AW-95-908

November 30, 1995

SUBJECT: WESTINGHOUSE RESPONSES TO NRC REQUESTS FOR ADDITIONAL
INFORMATION ON THE AP600

Figure 440.492-1 NOTRUMP - Upper Plenum Collapsed Liquid Level for Test SB01

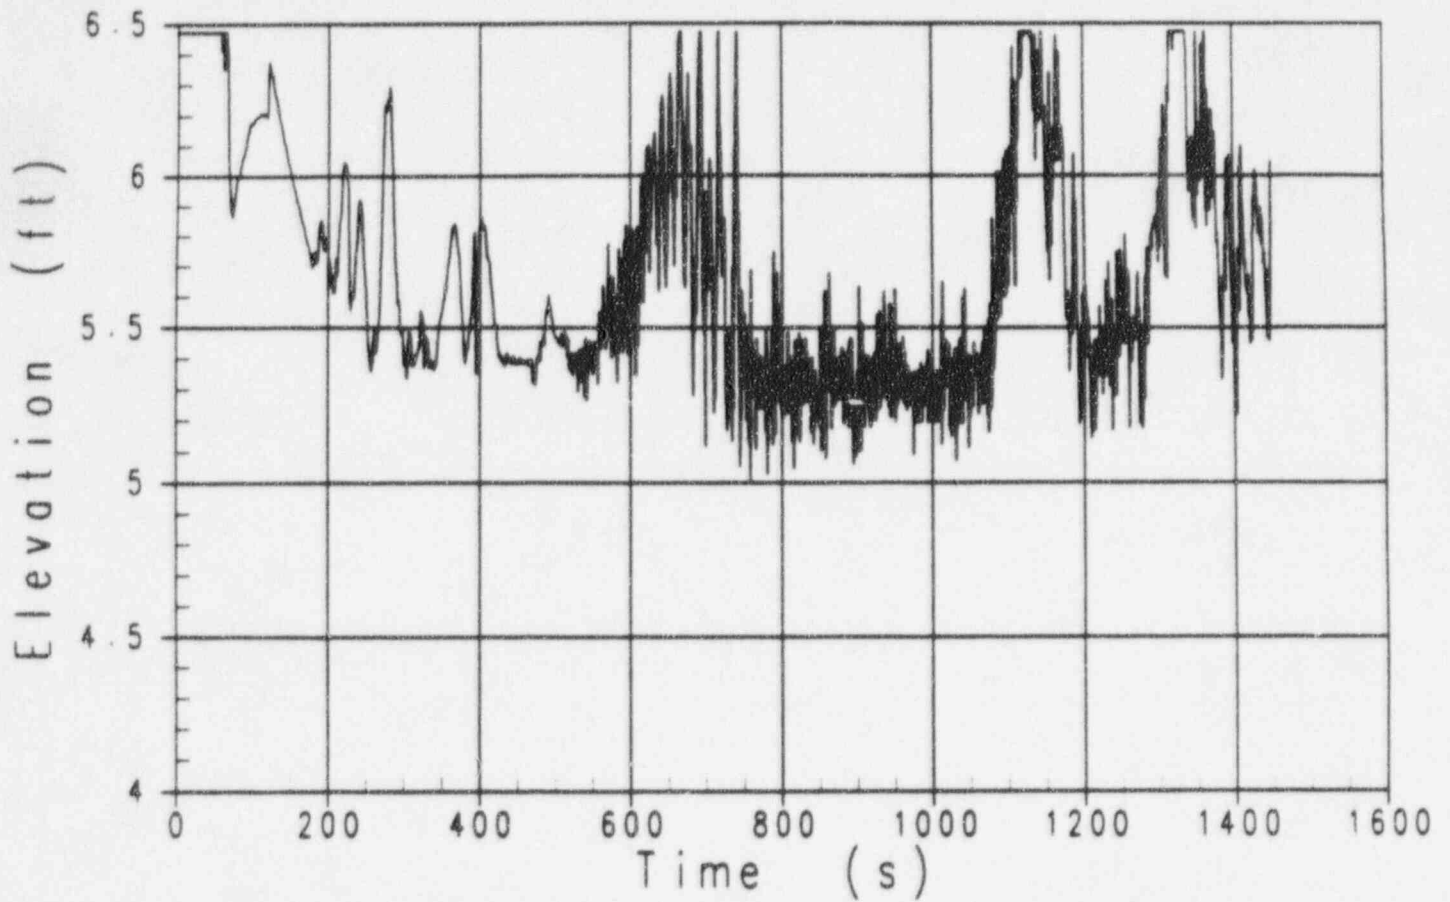
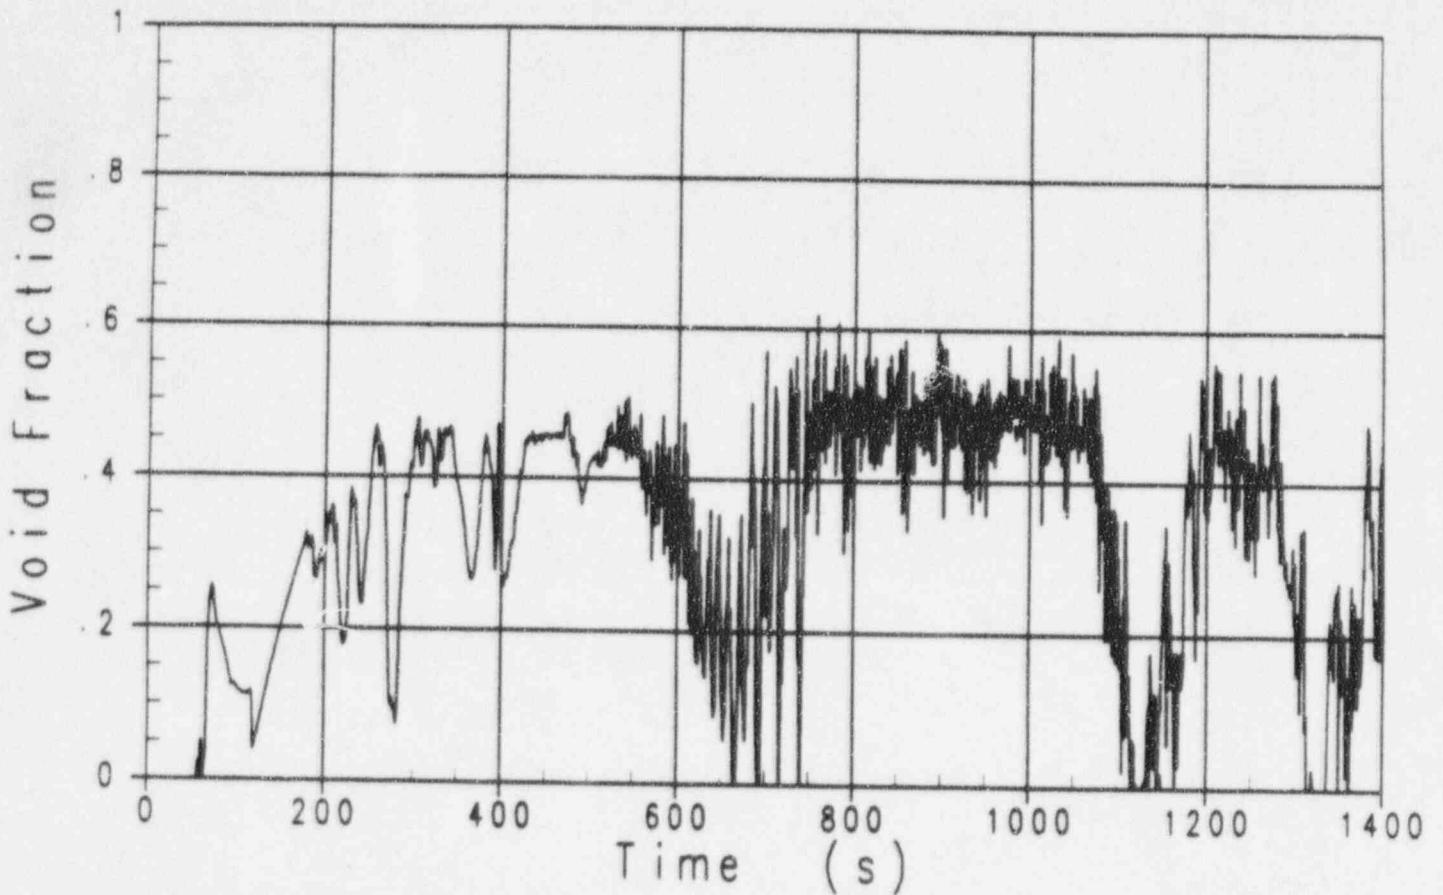
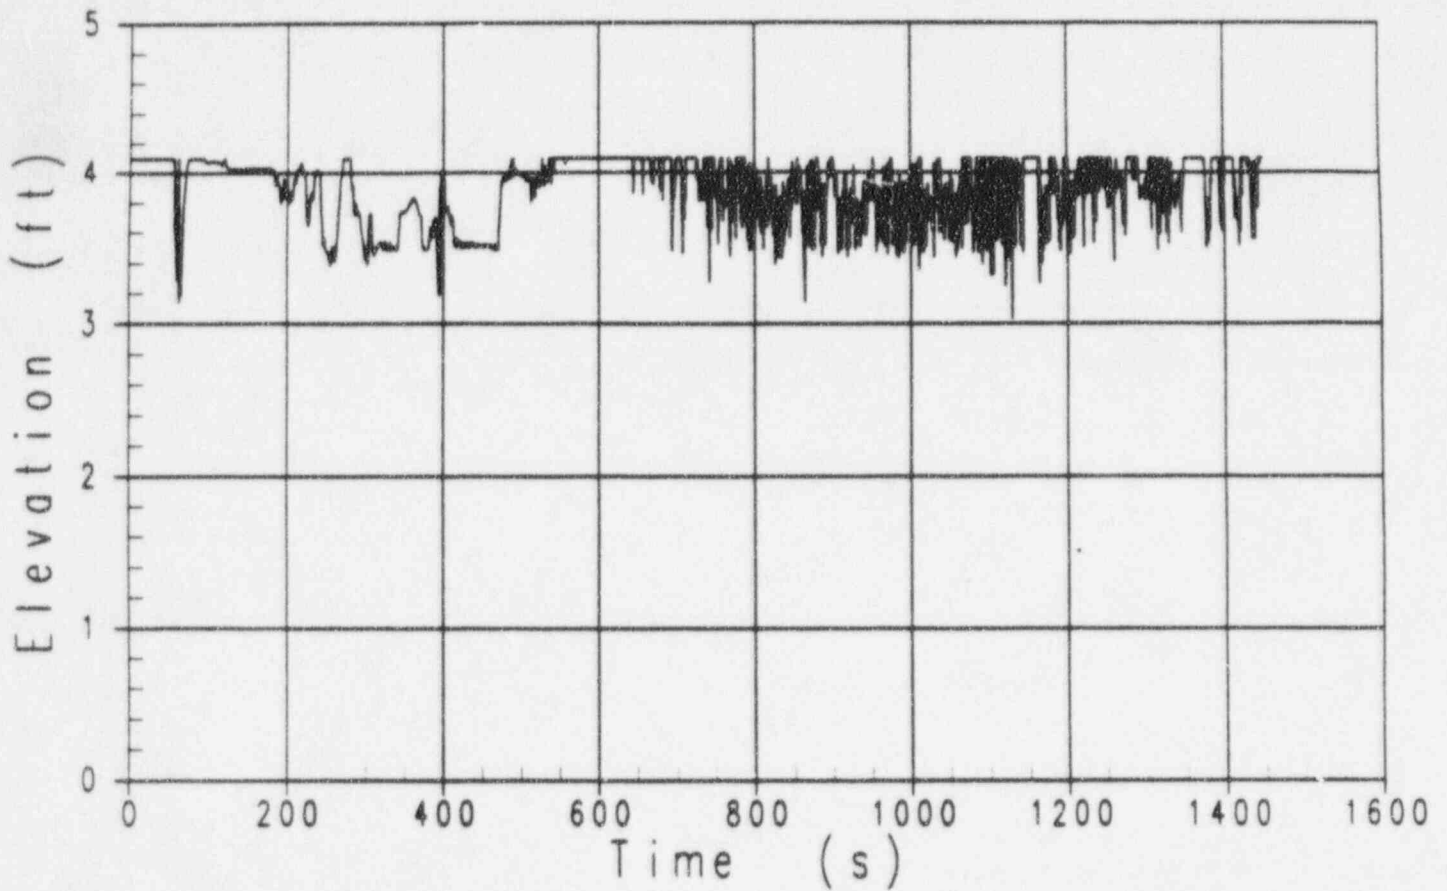
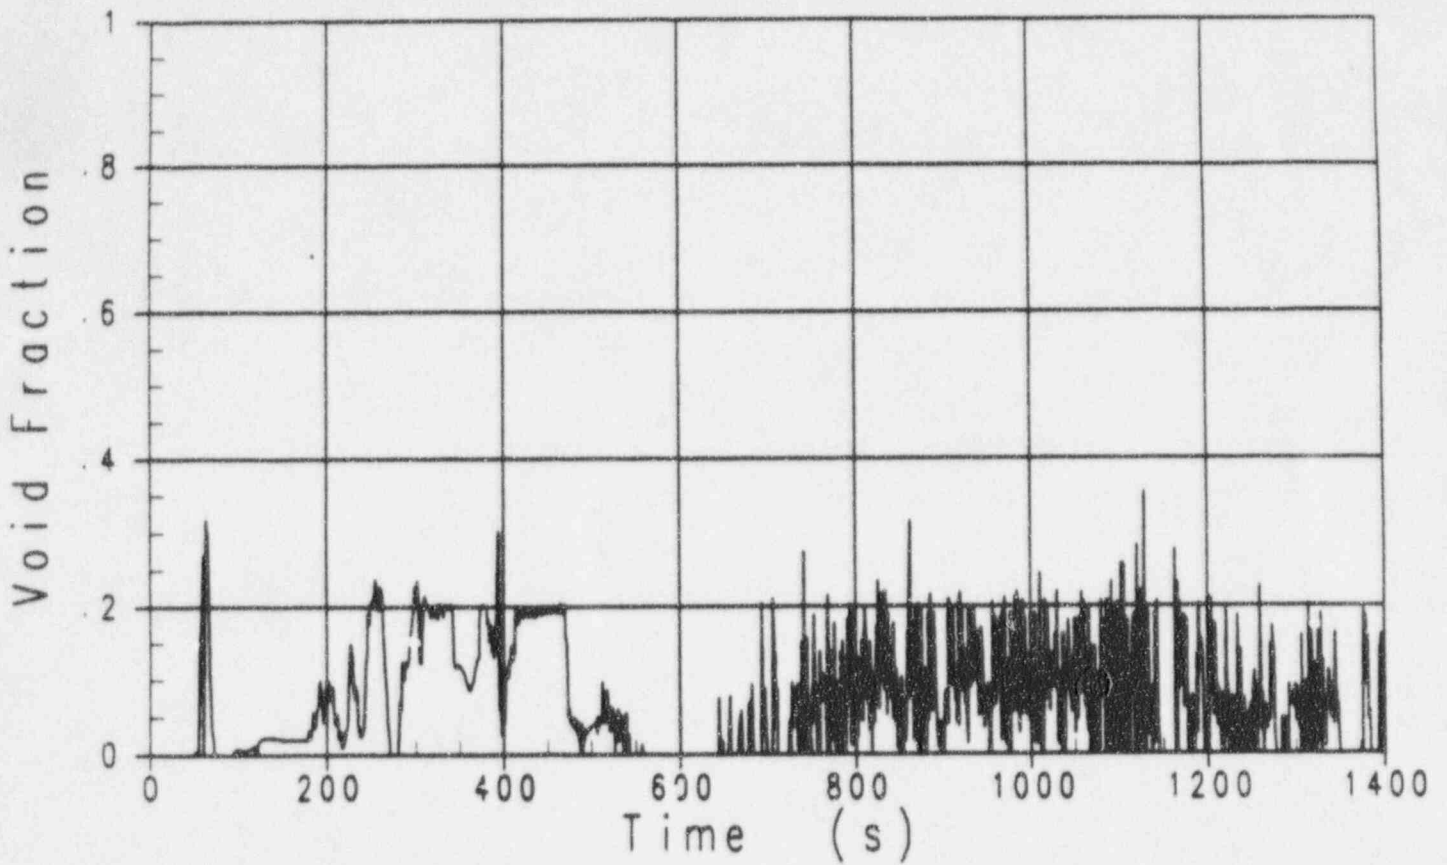
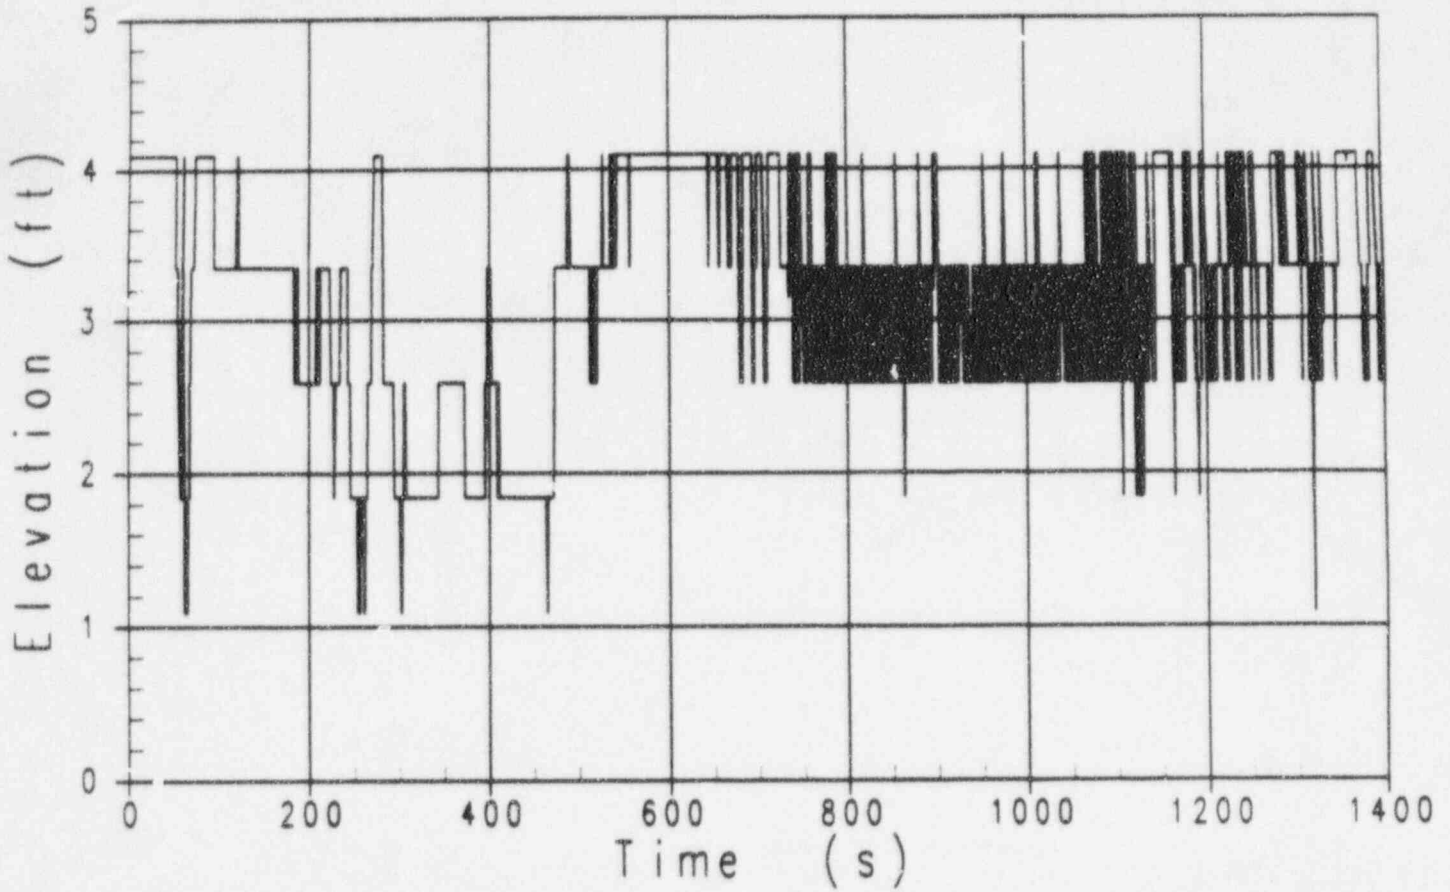
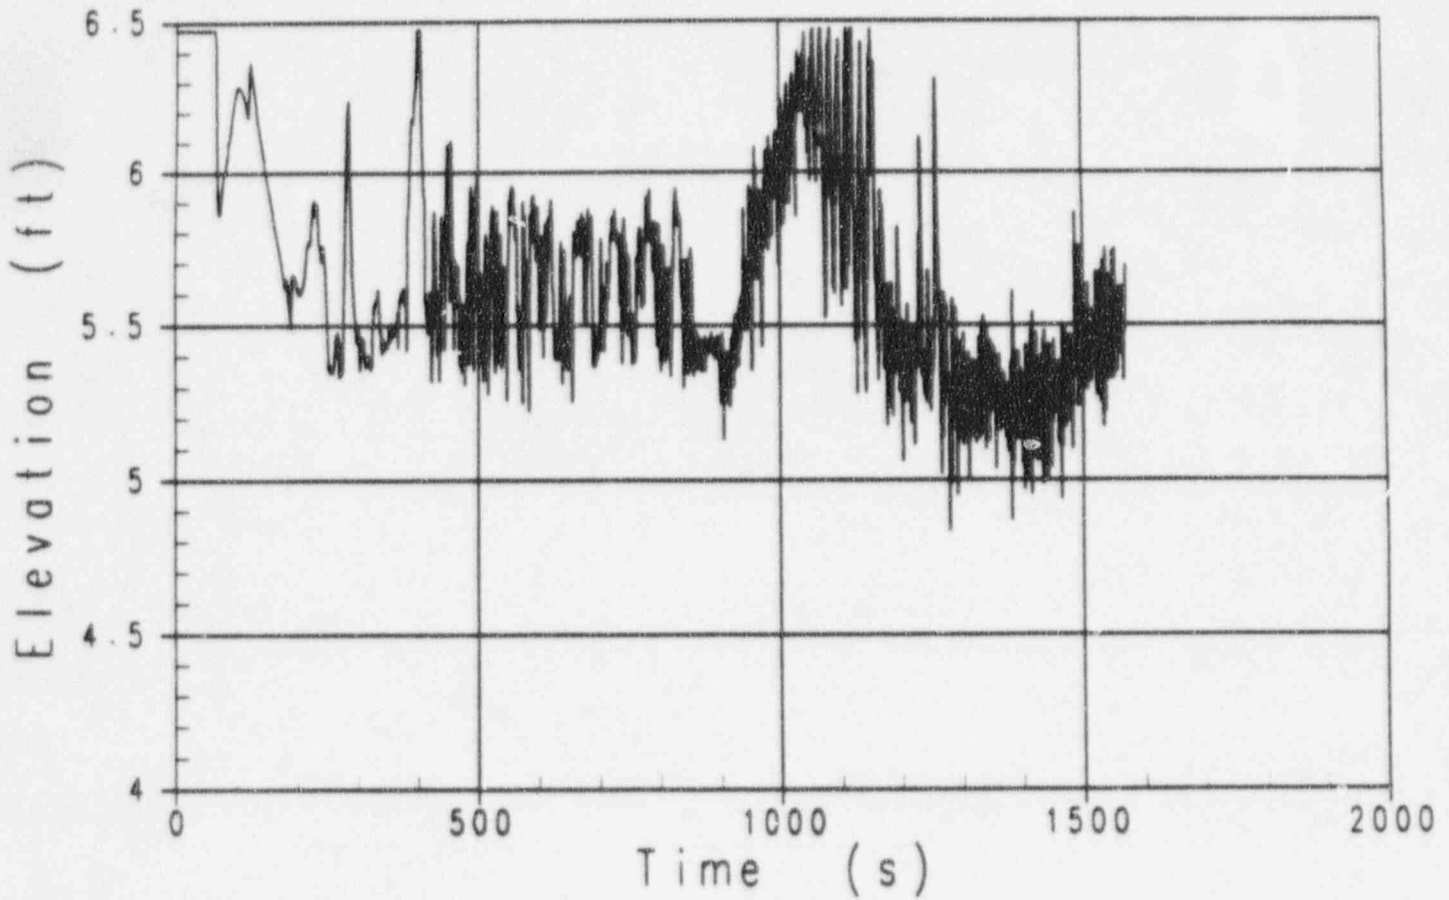
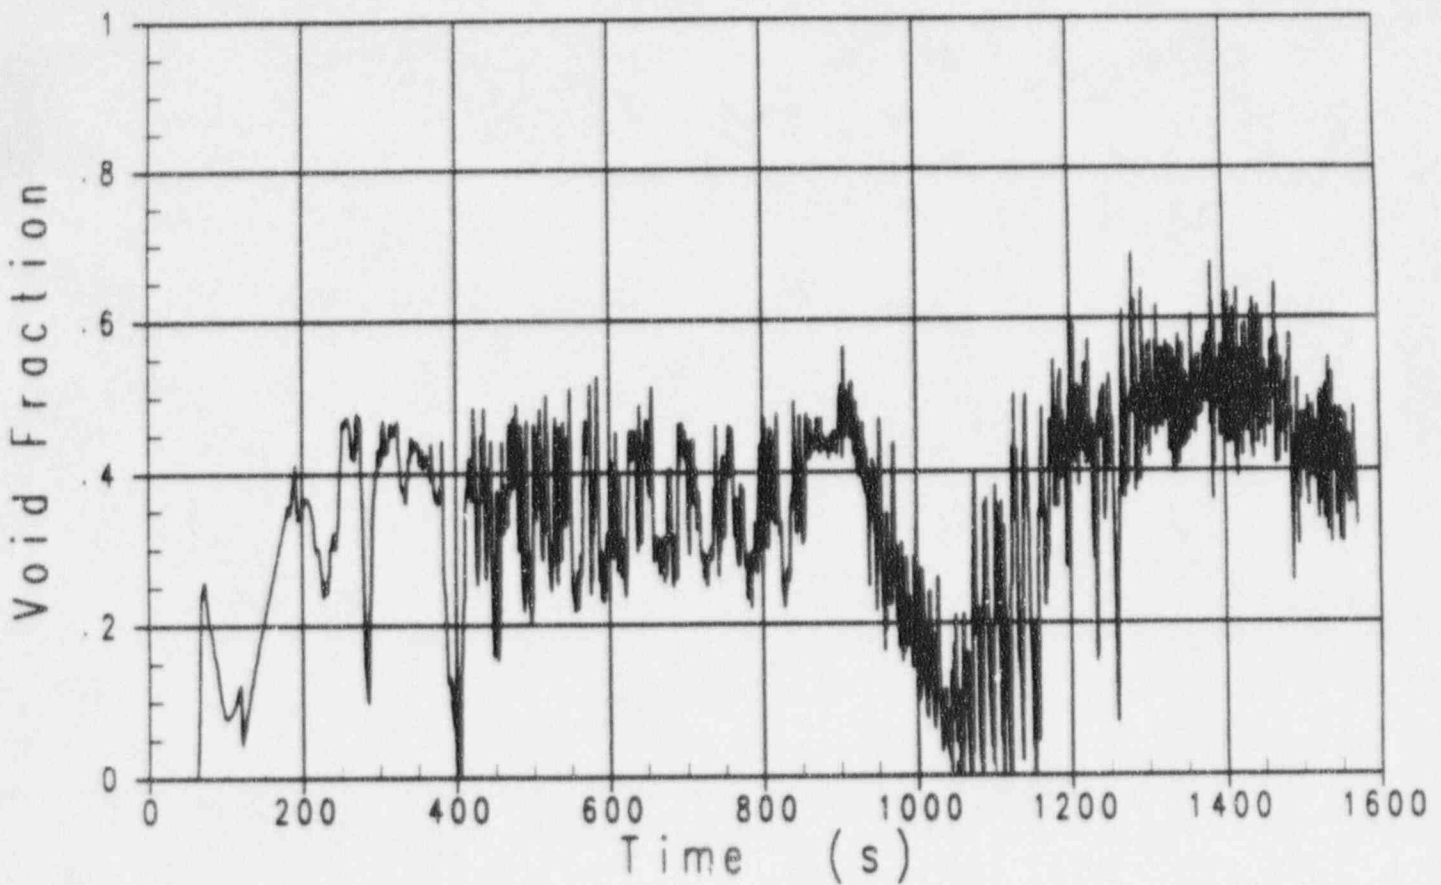
Please provide the core inlet and bypass mass flow rate predictions for the blind two inch cold leg balance line break of Section 5.2. Also, provide the liquid level plots for the upper plenum and core region and the void distribution in the core region.

The requested NOTRUMP core inlet and core bypass mass flow rate predictions for this test are provided in the response to RAI 440.491.
